# Camden Square Conservation Area Advisory Committee

**Planning application Reference:** 2021/5203/P

**Proposal:** Installation of extract duct to rear of property

*Figure 1 Screenshot with blue arrow showing duct in neighbouring building as seen from Camden Road*

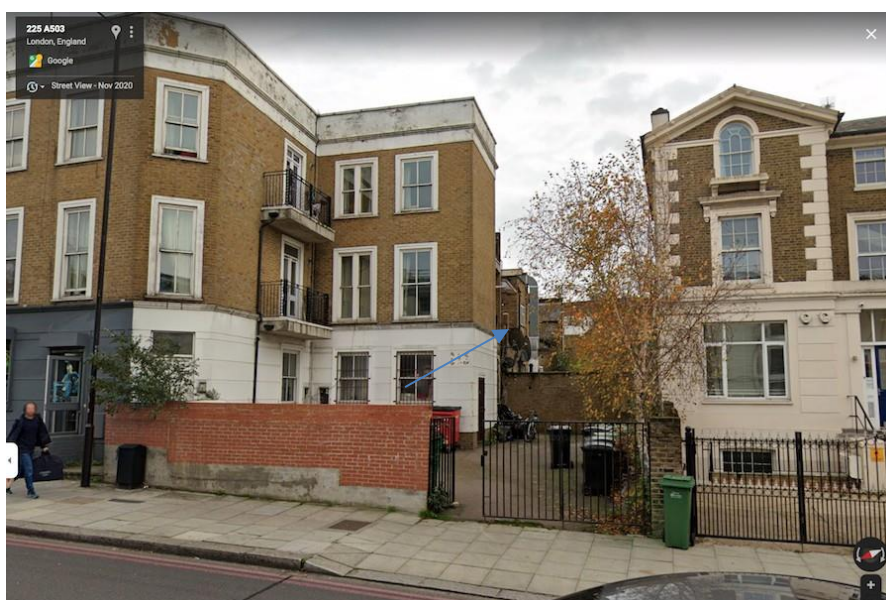
- 5.5. The position of the proposed duct is readily visible from Camden Road, also in the Camden Square Conservation Area. As the application photos do not show this, a Google Street View screenshot is attached to do so. (See Figure 1) A close look at the screenshot will also show an obtrusive extract duct further along the backs of York Way, and there is inadequate information to suggest that an extract duct here would end up being any less unsightly.
